**Submission
No 1**

INQUIRY INTO IMPACT OF THE ROZELLE INTERCHANGE

Organisation: Inner West Bicycle Coalition

Rozelle Interchange and Parklands Cycling Defects and Recommendations Report February 2024

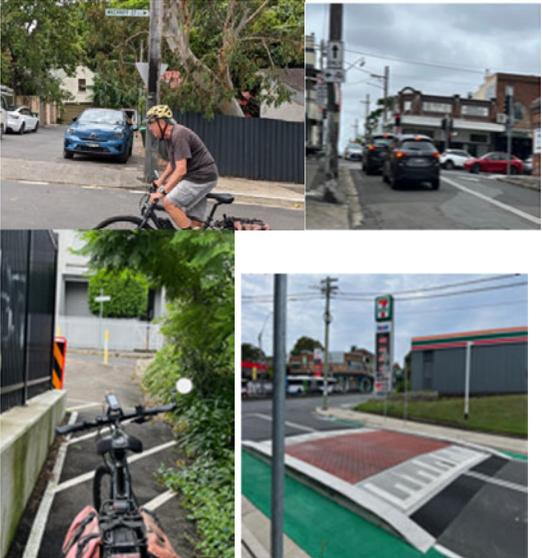
Item	Problem	Recommendation	Illustration
1	Victoria Rd shared path past White Bay Power Station remains narrow, is obstructed by dangerous signage and poles and has poorly designed ramping. No bicycle lights on crossing.	Ramp needs to be wider (or better angled) to cater for two directional bicycle traffic along Victoria Rd shared path near Robert St. Consider running the path behind the hoarding and fence allowing more space and a better grade. Install bicycle lanterns at Robert St crossing.	
2	No protection from errant vehicles mounting kerb.	Provide protective barriers, or relocate cycleway behind fence on White Bay Power Station land.

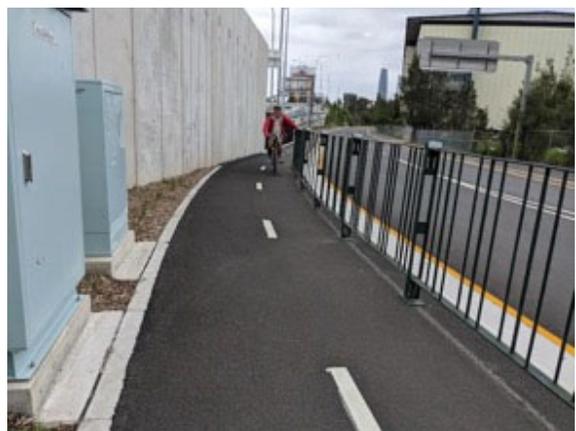
Item	Problem	Recommendation	Illustration
3	Turn into Lilyfield Rd from Victoria Rd is dangerous for cyclists, with no permanent clear warning to motorists of cyclists' presence	Provide formal pedestrian/cyclist crossing of Lilyfield Rd further west of Victoria Rd to allow safe passage of cyclists across Lilyfield Rd and clear notice to motorists of cyclist/pedestrian presence and movements.	 The illustration consists of two photographs. The top photograph shows a street intersection from a high angle. A dark-colored car is in the process of turning right from a road onto another road. The road surface has white dashed lines. The bottom photograph shows a close-up of a red post with a white sign that reads 'LOOK RIGHT' with a blue arrow pointing to the right. The sign is placed on a sidewalk at the corner of a street. A silver car is partially visible in the background.
